# Product Improvement Announcement

## New Poly Receptacle Casing for DS60, DS100C, DR100, DSDC6, DS7c, and DR7c

Issue date: 30 June 2022

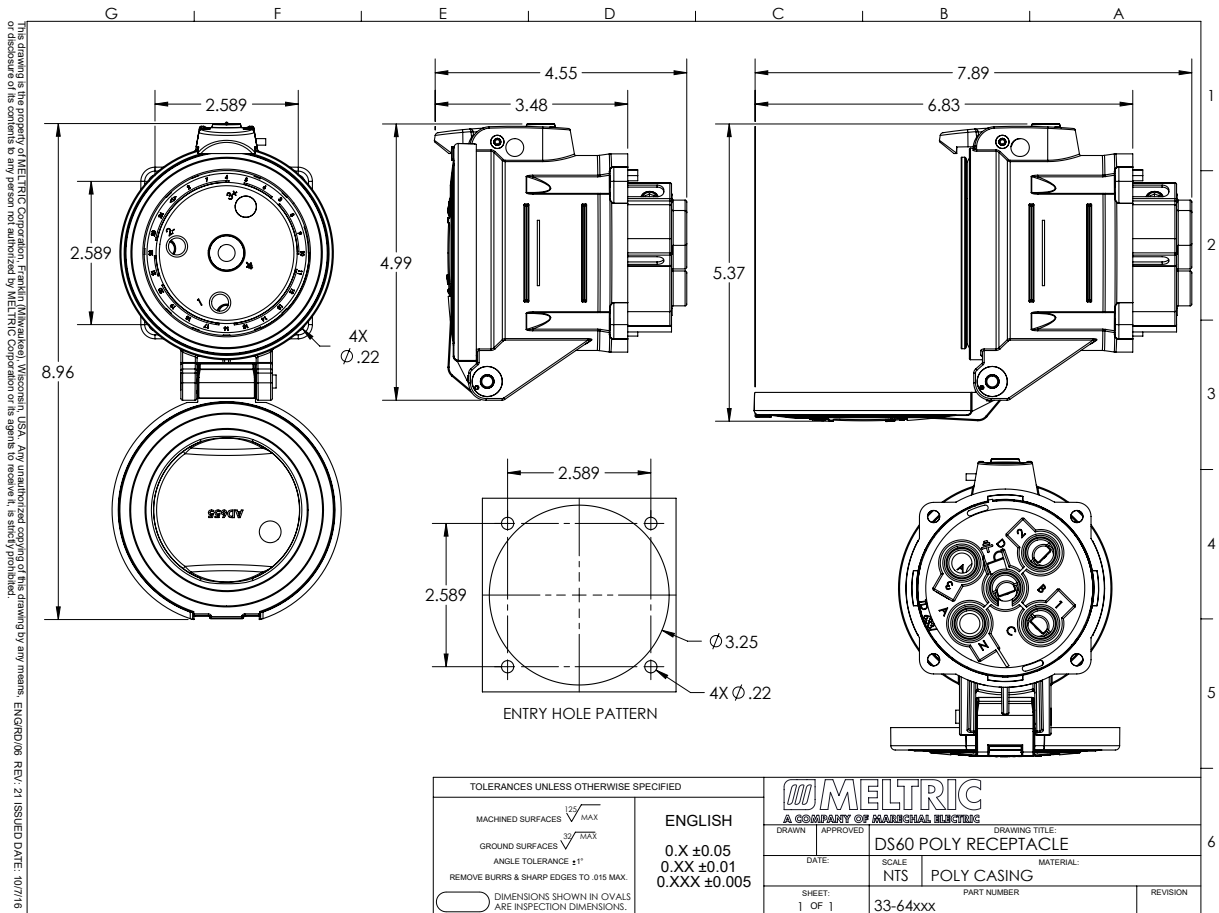
If the inlet to be mated with this receptacle is rated Type 4X and equipped with a gasket as shown, it is necessary to remove the gasket. It is normal that some gasket material remains stuck to the inlet. This will not compromise watertightness ratings.

If the inlet that had gasket removed will also be used with old style receptacle, then enclosed gasket should be temporarily installed according to the following instructions.

1. If gasket provided has adhesive backing, install with paper side down. \*Do not remove paper.

2. Work the gasket down to the inlet shoulder.
